Modifications to the Collar for the
Vertically Split Yoke SSC Collider Dipole Magnet

Jim Strait
Fermilab
19 July 1990

Figure 1a

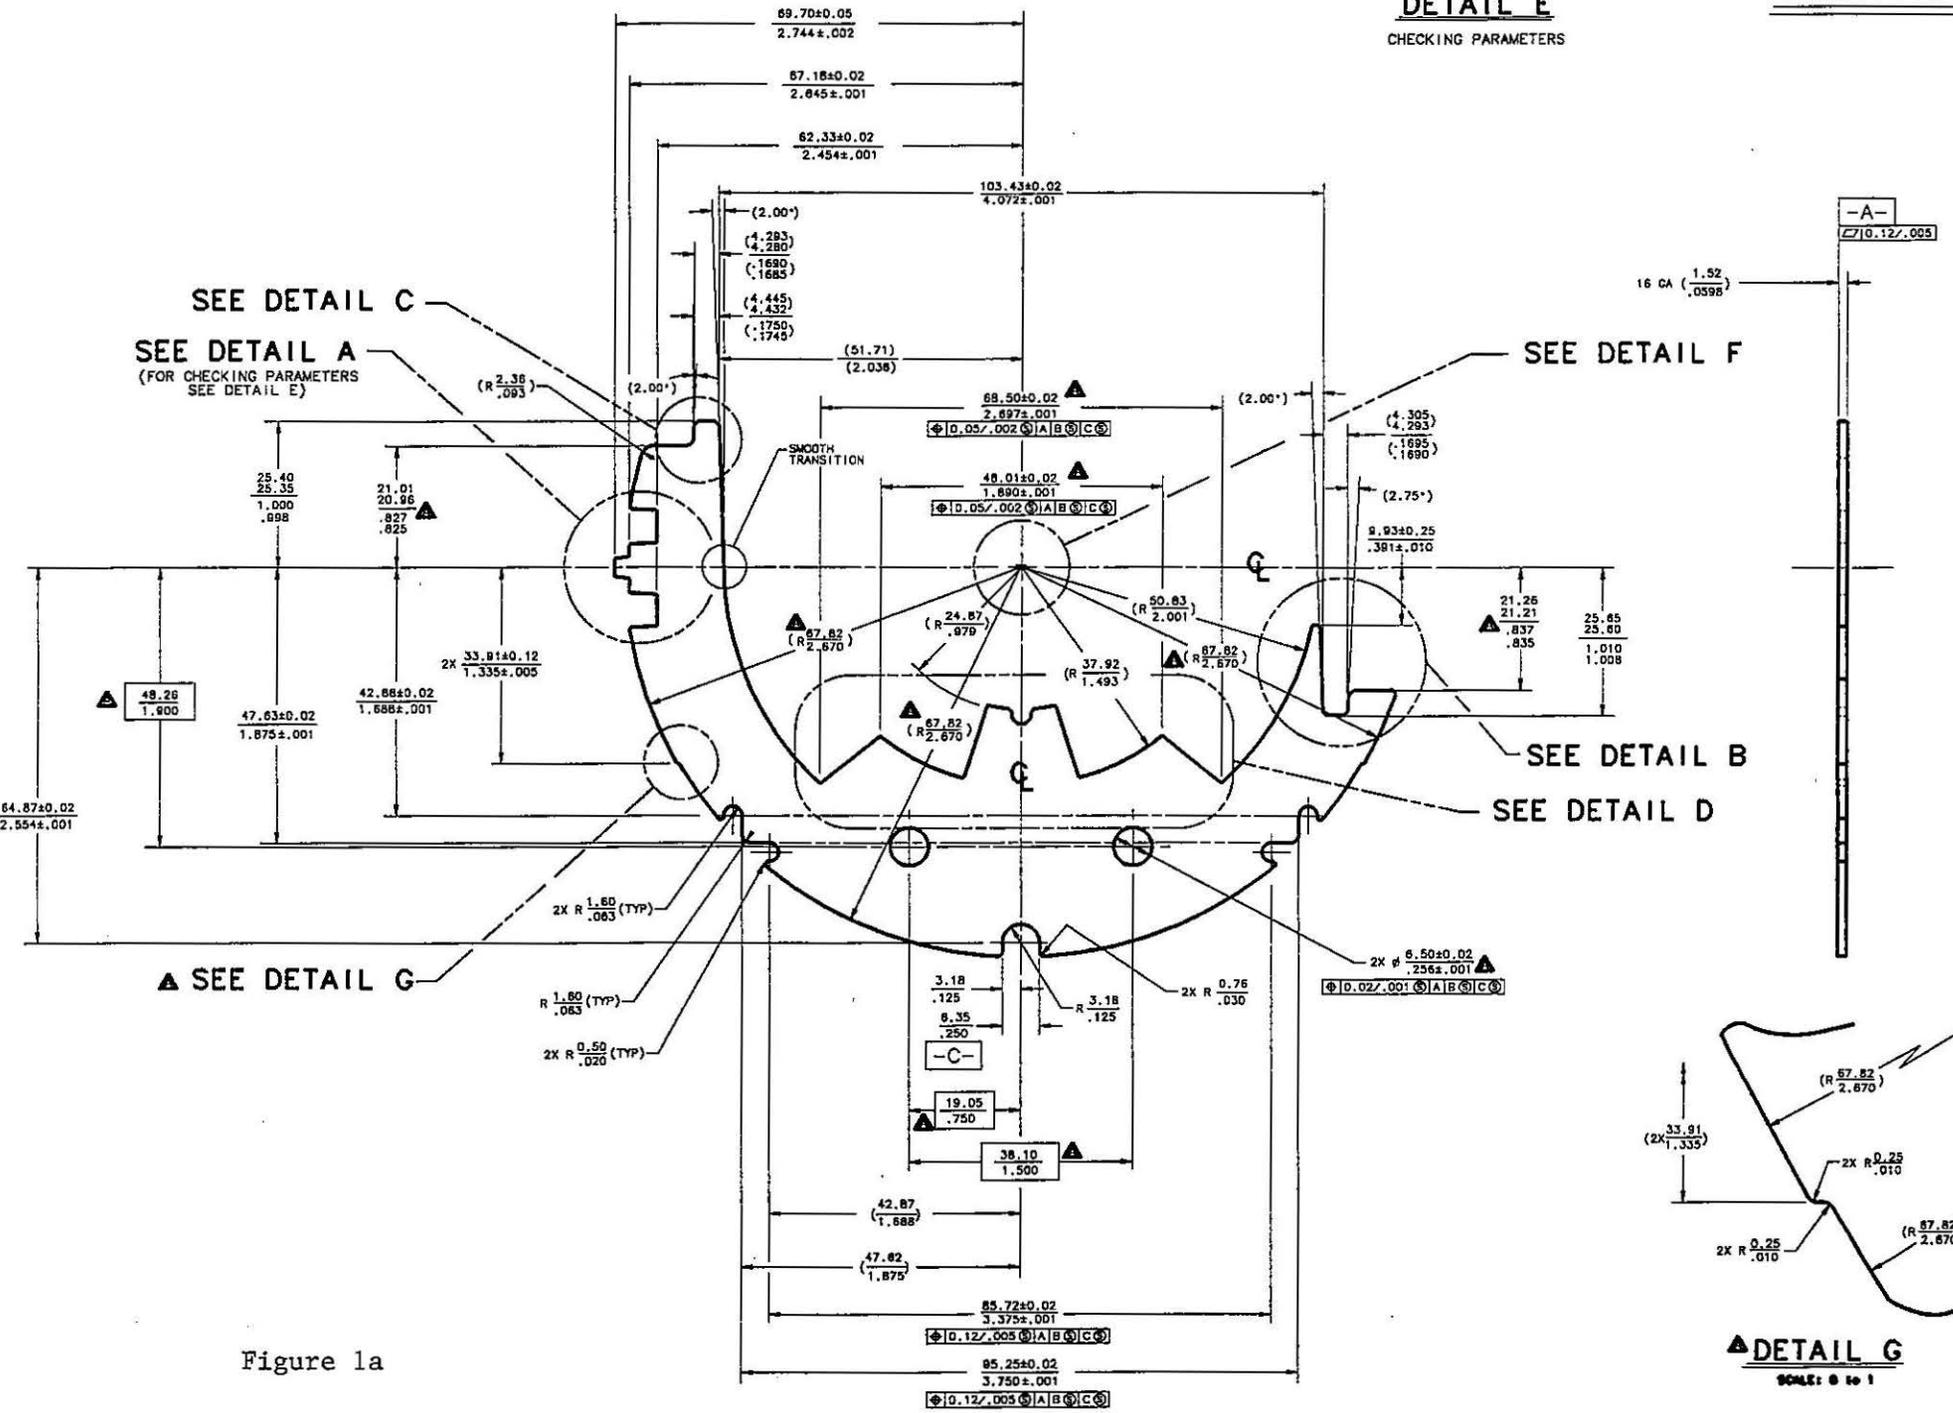
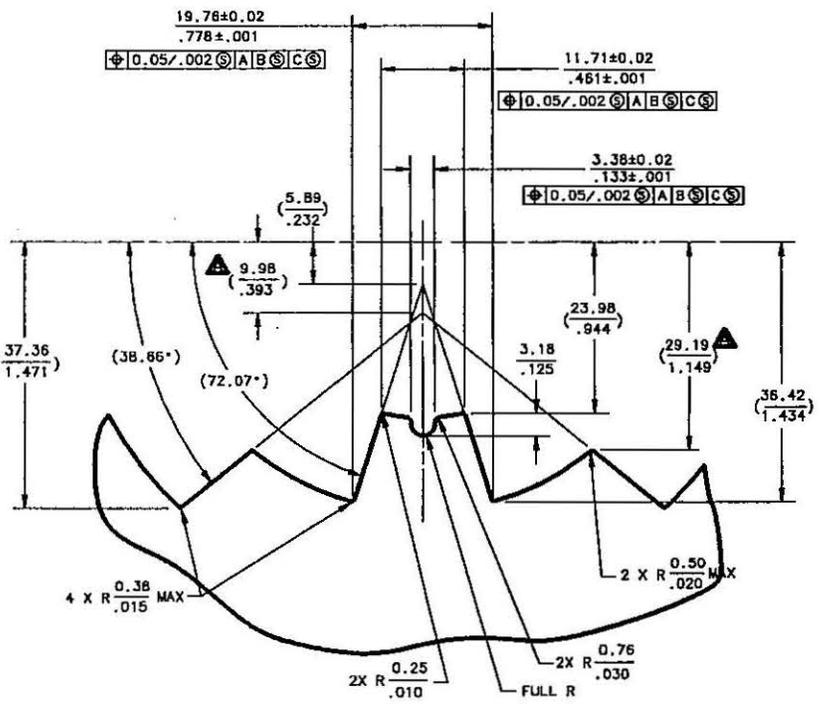
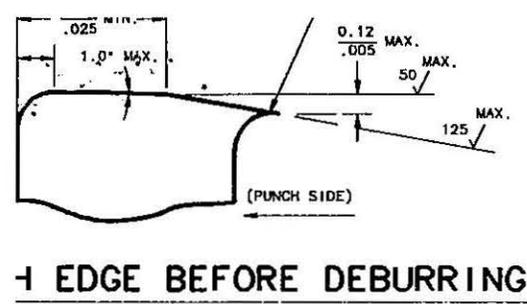
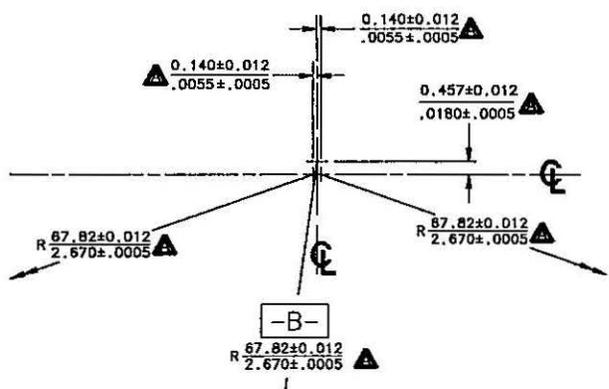
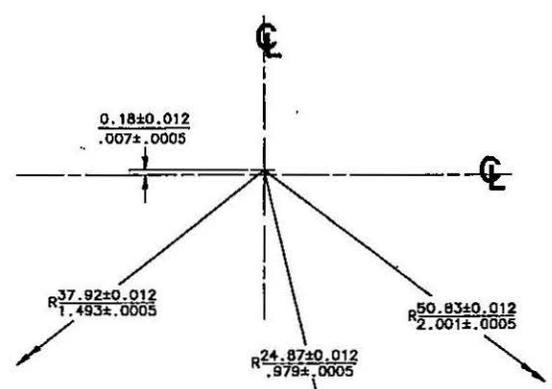
In two recent notes [1,2] I specified the shapes of the inner and outer surfaces of the collars for the vertically split yoke version of the 50 mm SSC collider dipole magnet. Two modifications to the design specified there have been made and are described in this note. The "final" collar design is shown in Fig. 1, taken from drawing 102-ME-292059.

The yoke-collar interface design calls for 5.5 mils of radial horizontal interference and 18 mils of vertical clearance between the yoke and the (undeflected) collar. In Ref. 1 this was accomplished by setting the collar radius to 10 mils larger than the yoke radius and offsetting its center down by 28 mils. This is represented by the dashed line in Fig. 2. (The collar is drawn only above 10° because the collars are designed to clear the yoke in the in the region of the keys.) As is clear from this figure and from Fig. 3 in Ref. 1, this shape will give a non-uniform stress in the yoke-collar contact area and the stress just above 10° may be very large. The new design has the radius of the outer surface of the collar equal to the yoke radius, but between 10° and 30° the center is shifted to the right by 5.5 mils and between 30° and 90° the center is shifted down by 18 mils. This is represented by the lighter solid line in Fig. 2. The maximum skin tension required to close the mid-plane gap is 24 kpsi [1], implying a maximum yoke-collar force of $24 \text{ kpsi} \times 0.188" = 4500 \text{ lbs/in}$. The arc length of the contact region is $0.93"$. Assuming a 50% die break for both the yoke and the collar, the actual contact area is about 25%. Thus the maximum contact stress is approximately 19 kpsi, well below the 40-50 kpsi yield of the yoke material. At 4 K and 8 T, the maximum yoke-collar force is about 6400 lbs/in, giving a contact stress of about 27 kpsi. In the original design the area of contact was approximately one-half as large and the contact was very non-uniform, resulting in the possibilities of local yielding.

The pole angle of the outer coil has been modified slightly following a suggestion by Ramesh Gupta (see attached e-mail) to set $b_2 = 0$. After the cross section was "fixed" and a considerable amount of tooling and parts had been ordered, particularly at BNL, the final dimensions of the cable were set at values slightly different from those assumed in the magnetic design. In particular, the inner cable width increased by 9 mils from the original design and by 6 mils from the first samples and the outer cable thickness was decreased by 0.4 mils. The increased inner cable width was handled by keeping the inner coil outer radius and pole angles fixed and reducing the inner radius by 9 mils. We (FNAL) had decided to handle

the decreased outer cable thickness by leaving the the mold and collar dimensions the same and counting on the epoxy to fill the extra 0.4 mils between cables. This would result in no change in the harmonics generated by the outer coil. BNL has apparently decided to mold the coil to a smaller size to maintain the same amount of turn-to-turn epoxy and add a 10 mil shim at the outer coil pole. Gupta has calculated the that the FNAL solution gives $b_2 = -1.0$ unit and the BNL solution gives $b_2 = +1.3$ units. The intermediate situation, adding a 5 mil shim, gives $b_2 = 0.2$ units and decreases the amount of "extra" turn-to-turn epoxy to 0.2 mils. We have now adopted this solution by moving the collar pole surface by 5 mils. (We also have a version of the collar which was designed to use a 25 mil pole shim on both the inner and outer coils; it now calls for a 30 mil outer coil shim.)
